**PROPOSED DISCOUNT FOODSTORE,
NON-FOOD RETAIL AND DRIVE-THRU RESTAURANT, UTTOXETER
ADDENDUM TECHNICAL NOTE
SEPTEMBER 2018**

- 1.4 This Note responds to comments prepared by consultant Amey which relate to the evidence presented within Vectos' April TA. This review was undertaken on behalf of SCC and presented within a Transport Assessment Review document.

Figure 1: Queue Length Variations (Source: TRL)

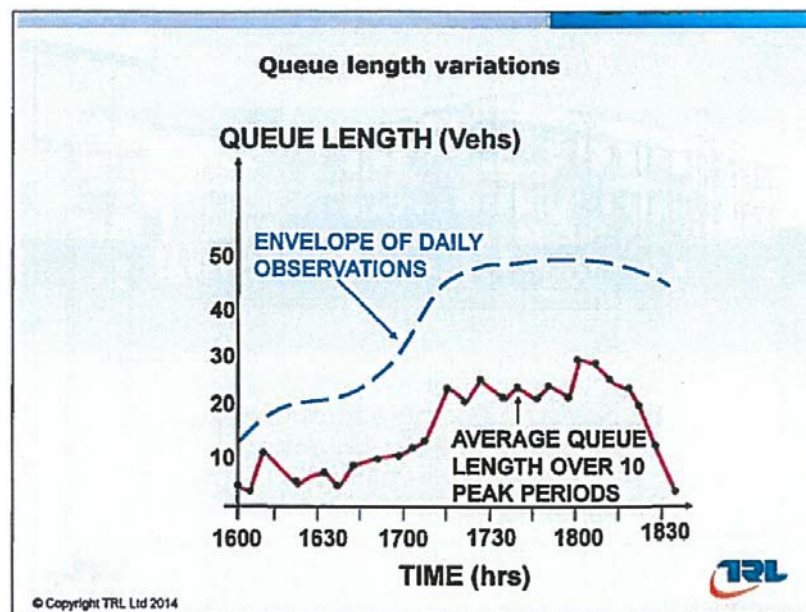
- 7.3 Turning to the ‘calibration’ and ‘validation’ of the models, Amey appear to suggest that queue information should be used for this exercise.
- 7.4 There are a number of practical difficulties in measuring mean queues over successive time intervals. During peak periods, when flow/ capacity ratios are high, TRL advises that there are large daily variations in queue lengths even if the average traffic flow for each time segment does not vary from day to day.

- 7.5 **Figure 1** illustrates an example of the large variation in observed queueing compared with the mean queue lengths.

- 7.6 DMRB Volume 12, Section 2, Part 1 also states that “precise validation of queue lengths can be difficult because of the volatility of the observed data” and does not provide an acceptable threshold for modelled versus observed queue lengths.

7.7 Therefore, the use of observed queue lengths to ‘calibrate’ and ‘validate’ ARCADY or PICADY models is limited and more weight should be applied to the review of demand flows and geometric inputs.

Traffic Figure 1

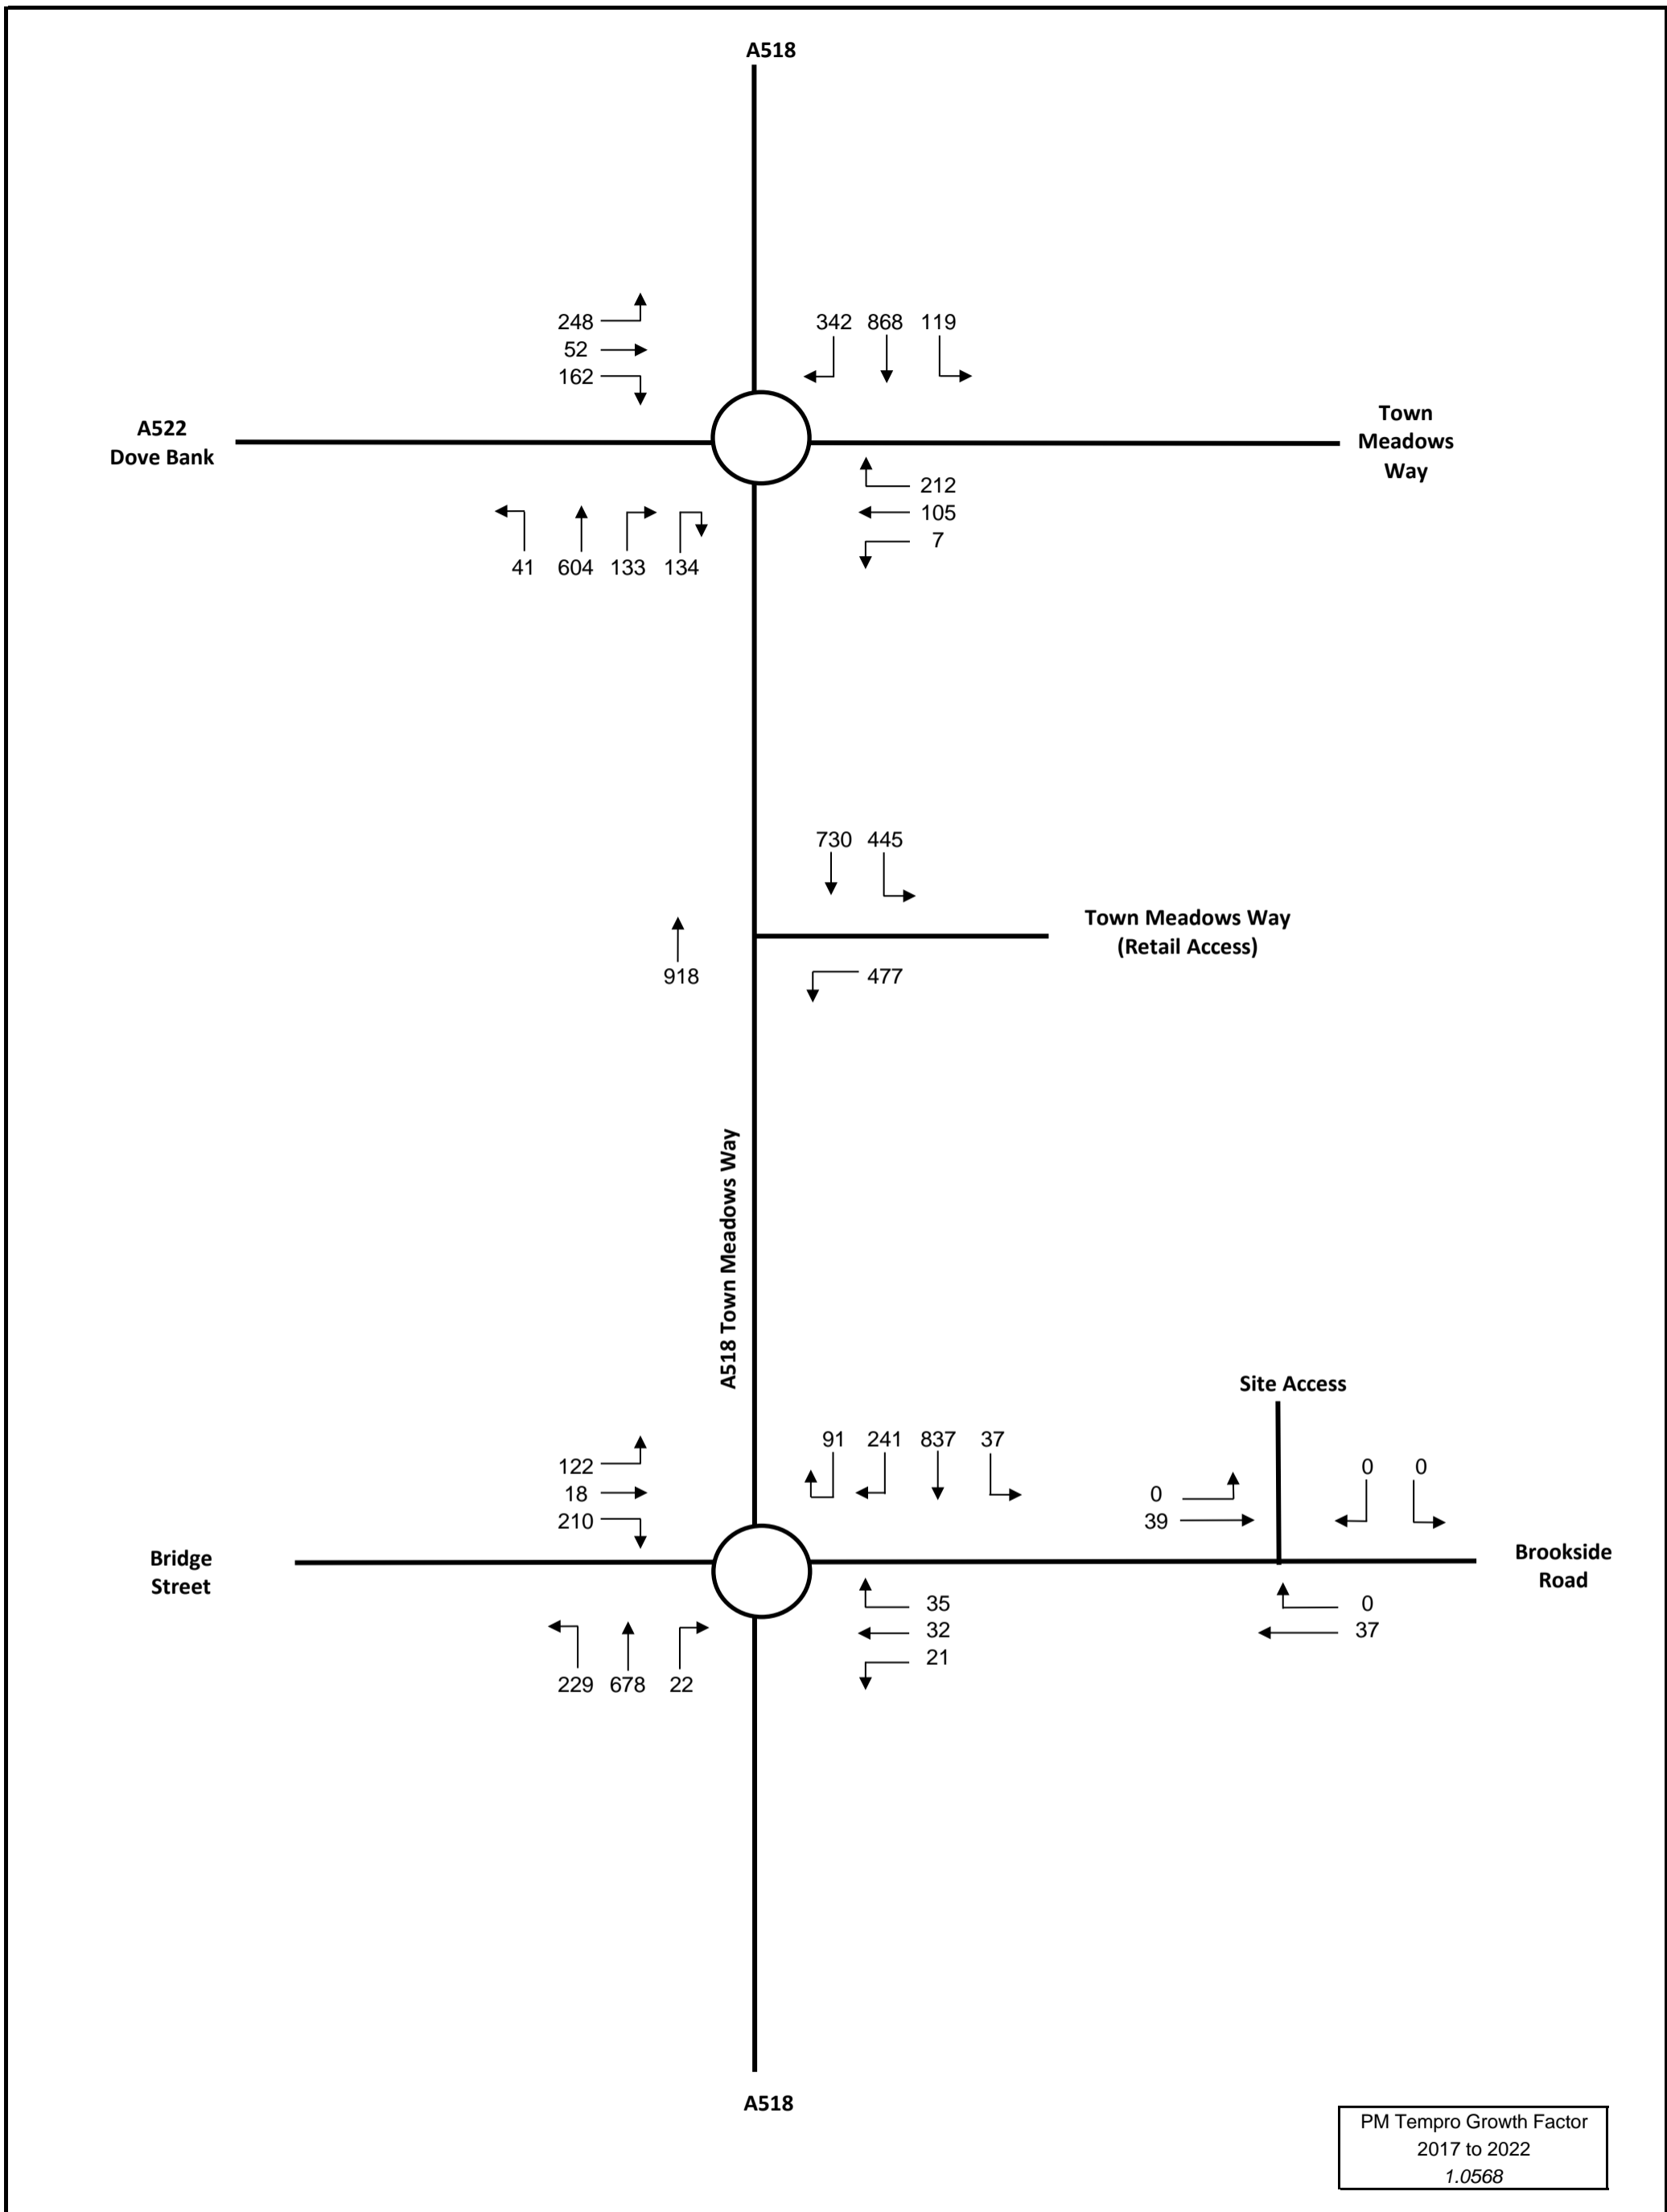
5.9 Amey identify two additional planning applications and have provided the following application reference numbers:

5.10 Amey have requested justification for the exclusion of these planning applications in our assessment.

- 5.16 As the SCP does not include an assignment of development traffic across the local highway network, however a distribution profile is included in the Transport Assessment prepared for extant consent OU/0525/018/JR/PO. Therefore, to accurately reflect the latest proposals, the extant consent distribution has been applied to the 148 dwelling trip generation forecast prepared by SCP.

- 5.17 It is noted that, SCP's report did not include a Saturday analysis presumably because the development was not considered to have a material impact during this time period. Accordingly, no allowance for the Saturday impact of this committed development has been included in our analysis. Therefore the resultant flows are shown in **Traffic Figure 1** for the PM peak.

DRAWING NUMBER: VN70855-D103	REVISION: .
---------------------------------	----------------

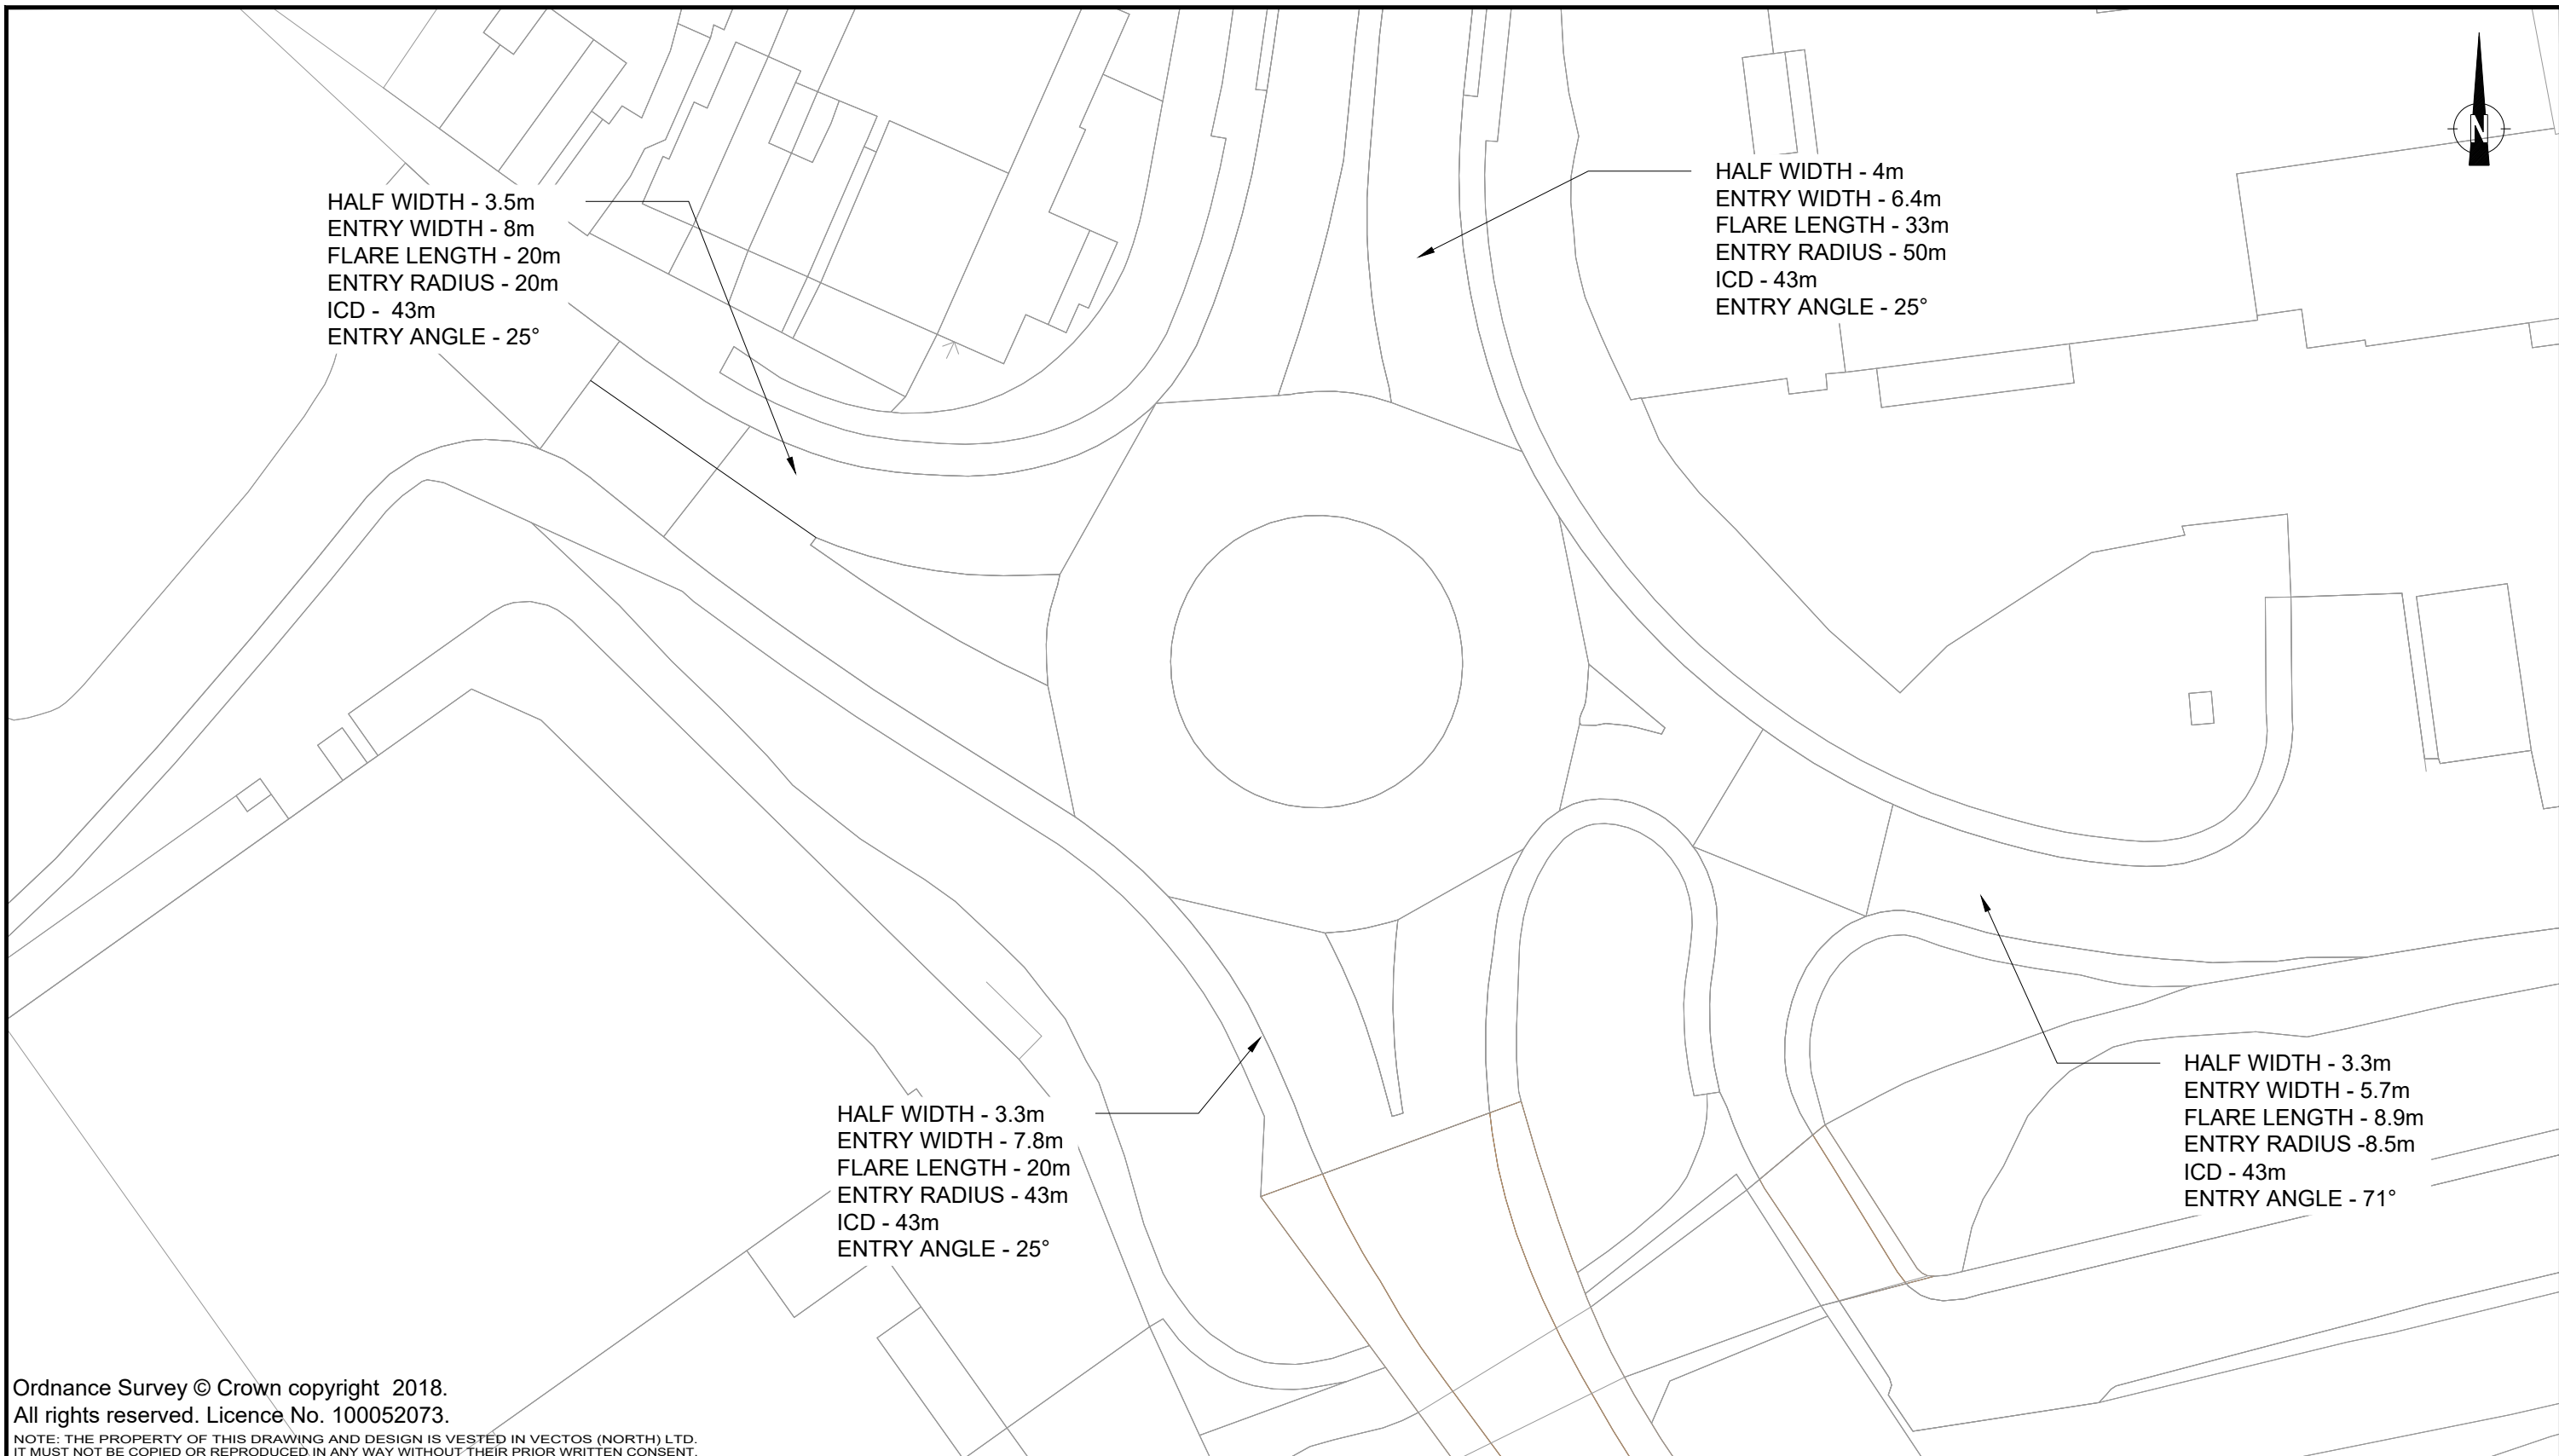
- 7.1 In their review, Amey indicate that until dimensioned drawings of the modelled junctions and evidence of model validation and calibration are provided, they cannot accept the assessments of the off-site junctions considered in the TA.

- 7.2 Scaled drawings of the A518 Town Meadows Way/ Brookside Road/ A518/ Bridge Street roundabout (**Drawing VN70855-D103**) and A518 Town Meadows Way/ A522 Dove Bank roundabout (**Drawing VN70855-D104**) have been provided at the rear of this report.
